# Access Compliance Report

### (Curb Ramps)

Intersection ID: 10016274	Main Street: COMMONWEALTH_AV	Cross Street: N/A	Location:	N
ADA ID: F464BFA0726E	Ramp Type: Perp	Initial Pass/Fail: Fail	Overall Compliance: No	Severity Score: 12.5
Codes/Mitigation Info/Possible Solution		Field Measurements/Component Compliance

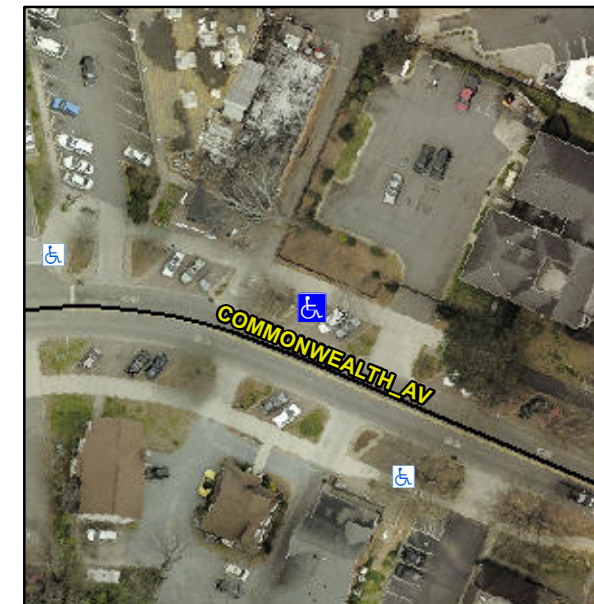
**Not Found, R304.2.2**

Compliance	Description	Data	Compliance	Description	Data
N/A	Ramp Length (in)	65.0	No	Ramp Slope (%)	9.4
Yes	Ramp Width (in)	59.0	Yes	Ramp XSlope (%)	0.8
N/A	Flare Type LT	N/A	N/A	Flare Type RT	N/A
N/A	Flare Slope LT (%)	N/A	N/A	Flare Slope RT (%)	N/A
N/A	Flare Traversable LT?	N/A	N/A	Flare Traversable RT?	N/A
N/A	Landing Length (in)	N/A	N/A	DWS Provided?	N/A
N/A	Landing Width (in)	N/A	N/A	DWS Contrast?	N/A
N/A	Landing Slope (%)	N/A	N/A	DWS Length (in)	N/A
N/A	Landing X Slope (%)	N/A	N/A	DWS Full Width?	N/A
N/A	Landing Curb? (Y/N)	N/A	N/A	DWS Offset (in)	N/A
N/A	Shared Landing?	N/A			
N/A	Gutter Ponding?	N/A	N/A	Gutter Slope (%)	N/A
N/A	Gutter Lip Ht (in)	N/A	N/A	Gutter X Slope (%)	N/A
N/A	Painted X Walk1?	No	N/A	Painted X Walk2?	N/A
	X Walk 1 Direction	To E		X Walk 2 Direction	N/A
N/A	X Walk 1 Width (in)	N/A	N/A	X Walk 2 Width (in)	N/A
	X Walk 1 Slope (%)	4.1		X Walk 2 Slope (%)	N/A
	X Walk 1 X Slope (%)	1.5		X Walk 2 X Slope (%)	N/A

**Remove & Replace Entire Ramp.**
